Subject: Duke Energy Carolinas, LLC
Oconee Nuclear Station, Units 1, 2, and 3
Docket Nos. 50-269, -270, -287
Emergency Plan, Volume A, Revision 2012-04

SUBJECT: Oconee Nuclear Site Emergency Plan
Volume A, Revision 2012-04

<u>REVISION NUMBER</u>	<u>EFFECTIVE DATE</u>	<u>REASON FOR REVISIONS</u>
2012-04	12/12	Section B - This change is to incorporate the new staffing analysis for the new EP rule and editorial changes.

FIGURE B-4A
OCONEE NUCLEAR STATION
Emergency Operations Facility

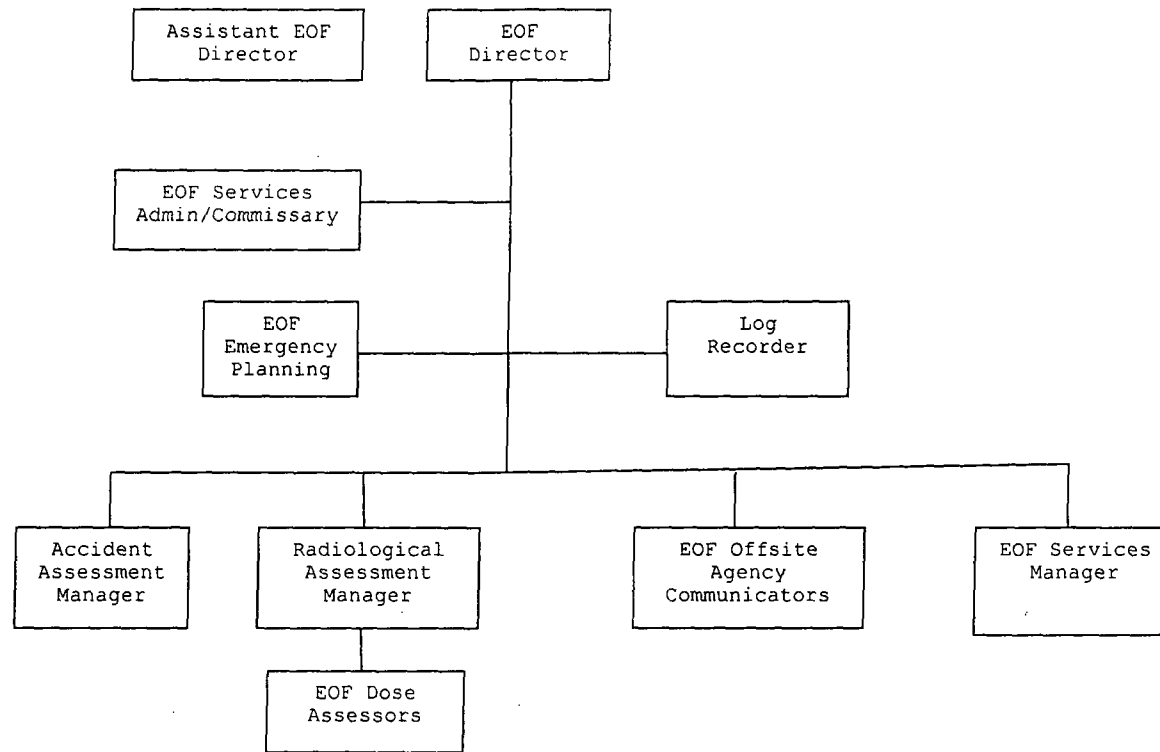
3. Figure B-1: Removed "DUKE ENERGY COMPANY" from title to maintain consistency.
4. Figure B-4A: Removed "DUKE ENERGY COMPANY" from title to maintain consistency.

FIGURE B-4C
OCONEE NUCLEAR STATION
EMERGENCY OPERATIONS FACILITY

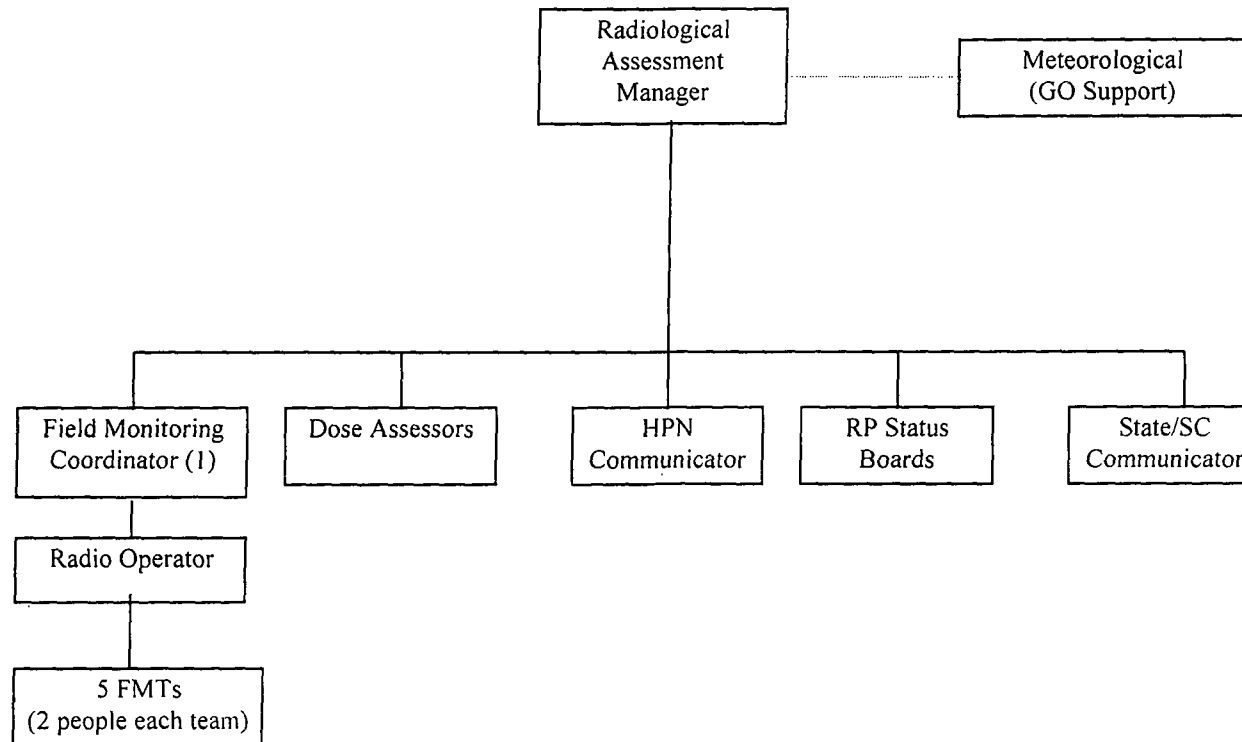
5. Figure B-4C: Removed "DUKE ENERGY COMPANY" from title to maintain consistency.
6. Figure B-5: Removed "DUKE ENERGY COMPANY" from title to maintain consistency.

FIGURE B-9
OCONEE NUCLEAR STATION
MINIMUM STAFFING REQUIREMENTS

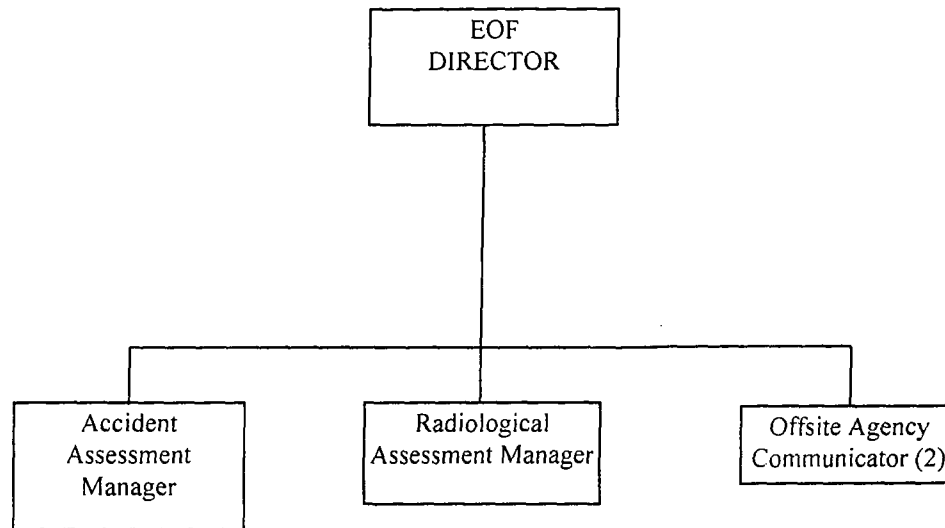
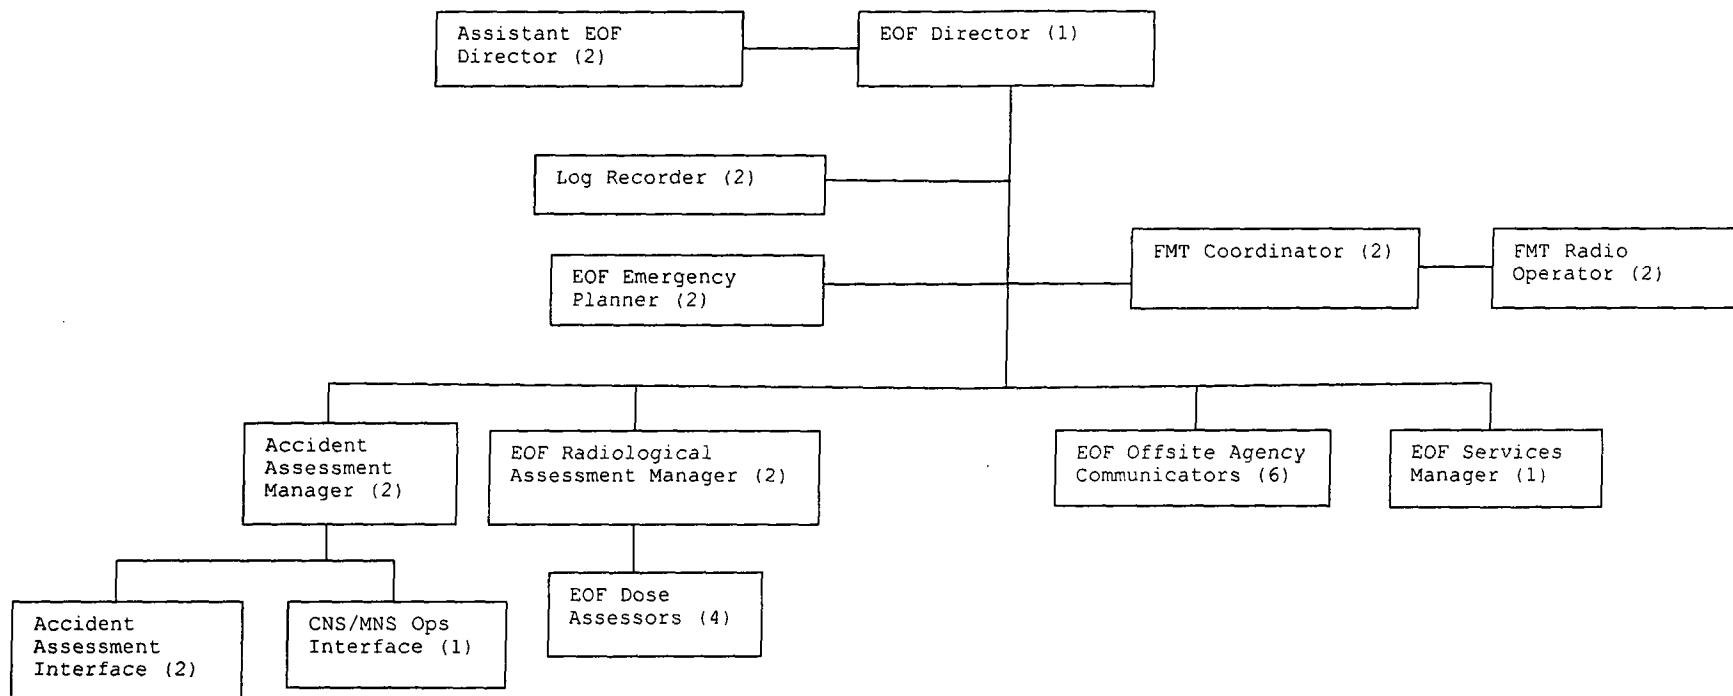
21. Figure B-9: Removed "DUKE ENERGY COMPANY" from title to maintain consistency.
22. Figure B-10: Removed "DUKE ENERGY COMPANY" from title to maintain consistency.
